UNITED STATES
NUCLEAR REGULATORY COMMISSION

SUBJECT: JULY 29 - AUGUST 1, 2003, MEETING SUMMARY: MEETING WITH
DUKE COGEMA STONE & WEBSTER TO DISCUSS OPEN ITEMS
RELATED TO MIXED OXIDE FUEL FABRICATION FACILITY

**MEETING SUMMARY
MOX FUEL FABRICATION FACILITY
July 29-August 1, 2003**

**DUKE COGEMA STONE&WEBSTER HANDOUTS
MOX FUEL FABRICATION FACILITY
July 29-August 1, 2003**

Results of Peak Temperature Calculation

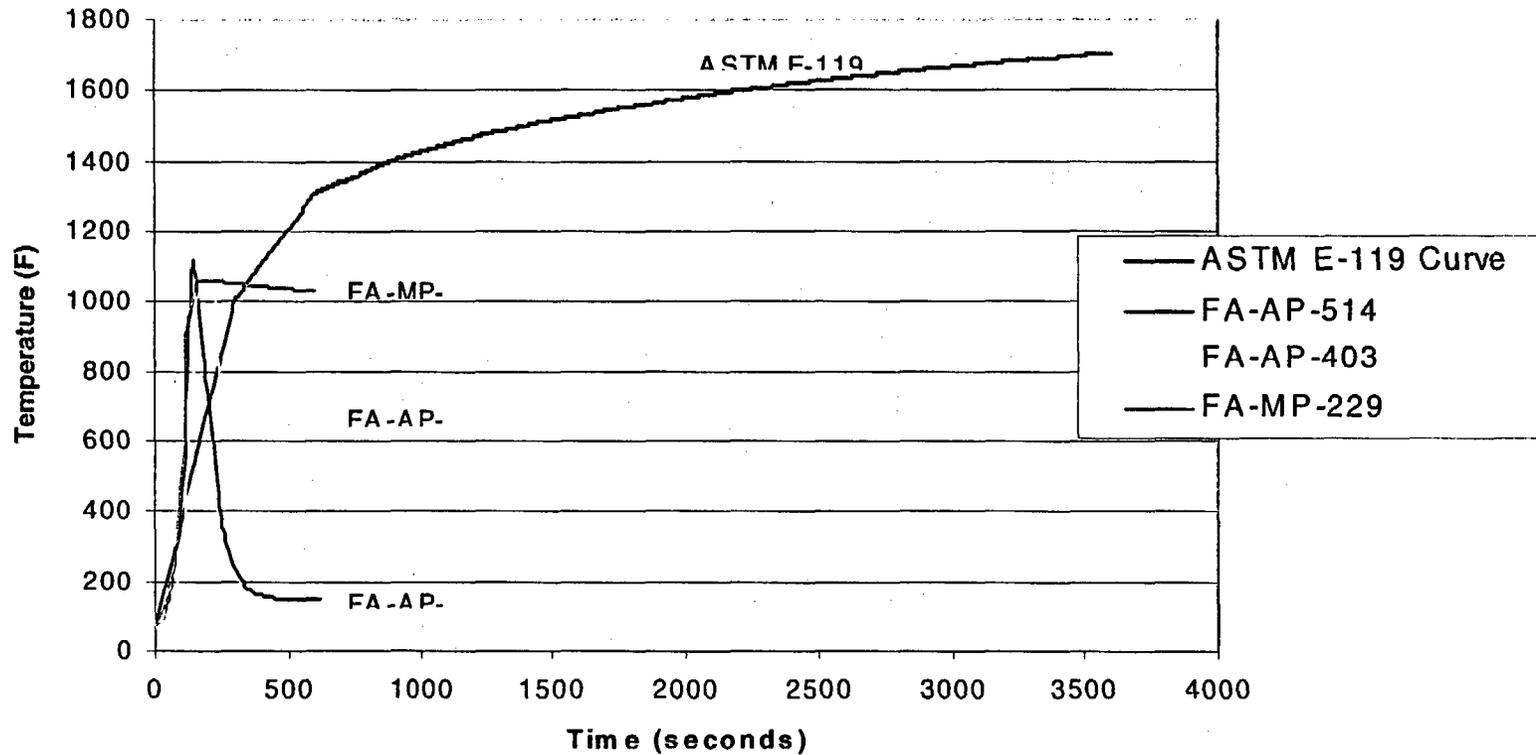
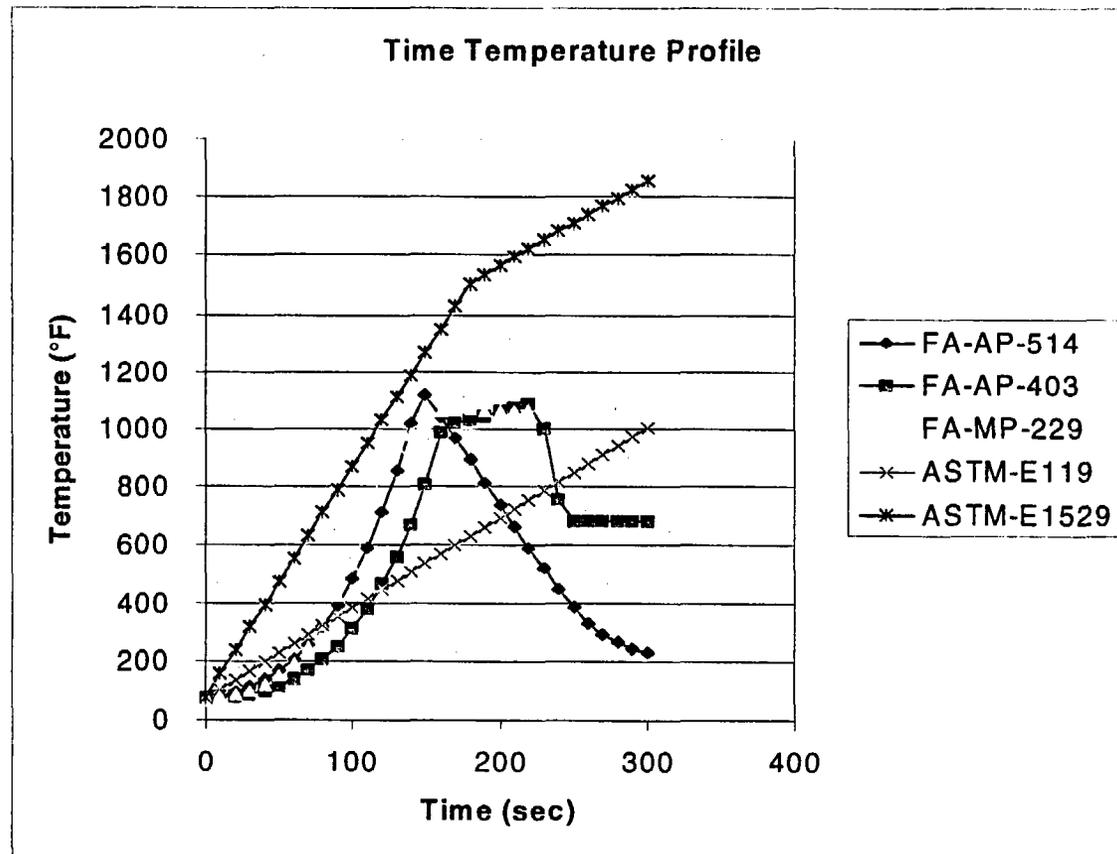
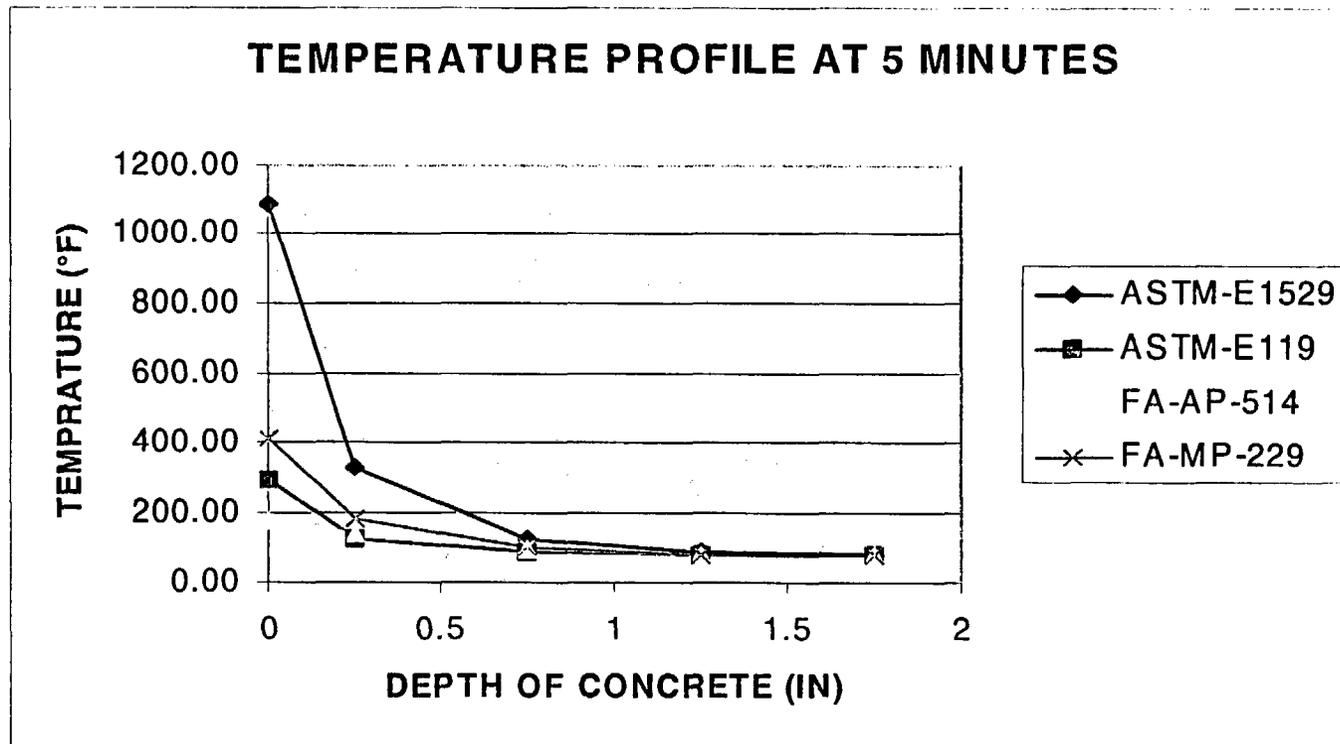
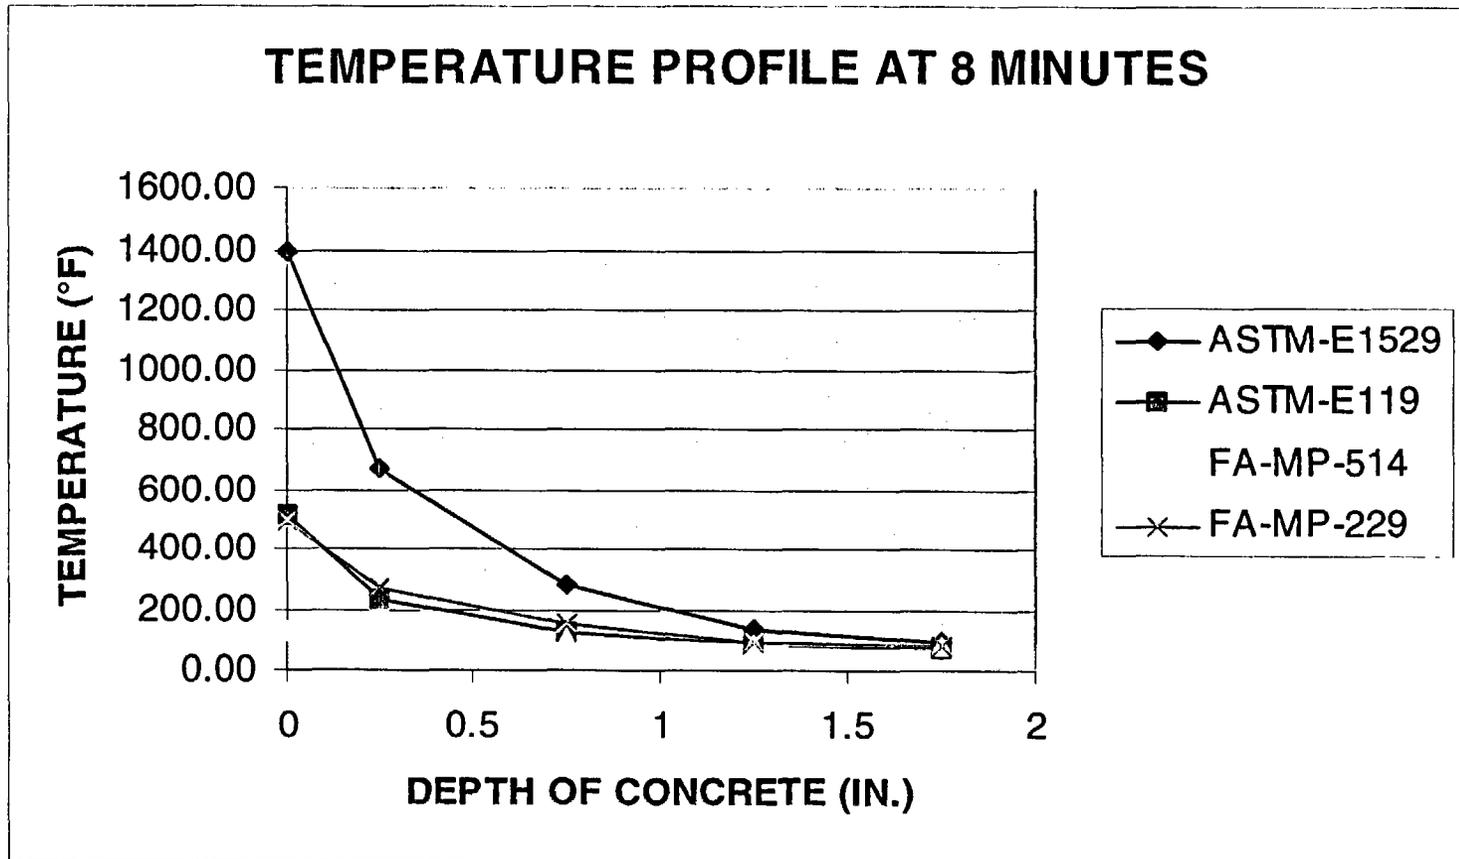
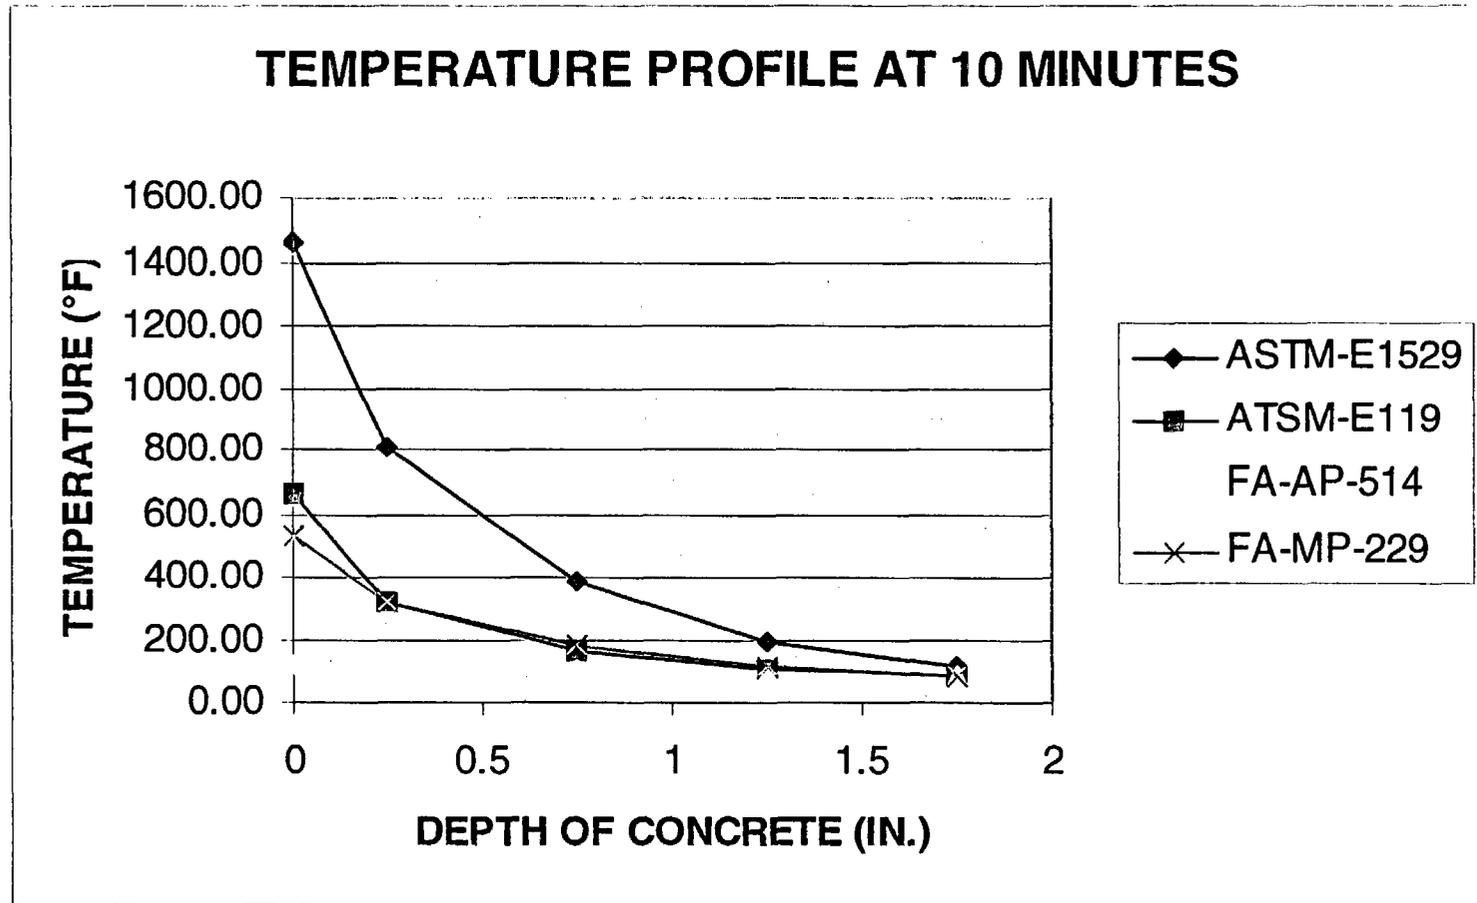
DCS described the results of its analysis regarding the effects on concrete where temperatures exceed the American Society for Testing and Materials (ASTM)-E119 fire curve. The analysis included calculating the room temperature as a function of time and then using finite difference methods to calculate the temperature as a function of depth in the concrete. The results are shown in Attachment 3. The conclusion is that under the time vs. temperature curve that was calculated for the compartment, the concrete temperature at a depth of one inch does not exceed 200 degrees F in the first ten minutes, and after the first five minutes, the fire temperatures level off or decline. Spalling has been found to occur only when the temperature exceeds 200 degrees F about an inch into the concrete. Therefore, DCS concluded that spalling would not be a concern should a fire occur.

Since two fire areas, even for a short duration, fall outside the E119 curve, a one-dimensional implicit finite difference analysis was performed to determine the temperature effects within the concrete.

All fire areas have temperatures under the E119 curve within 5 minutes and level off at this point.

It can be seen from this graph that within 8 minutes, the concrete is within the E119 curve and the concrete temperatures are below 200 °F at 1 inch into the concrete.

The concrete temperatures at 1 inch are still less than 200°F for the fire areas and E119 curve.
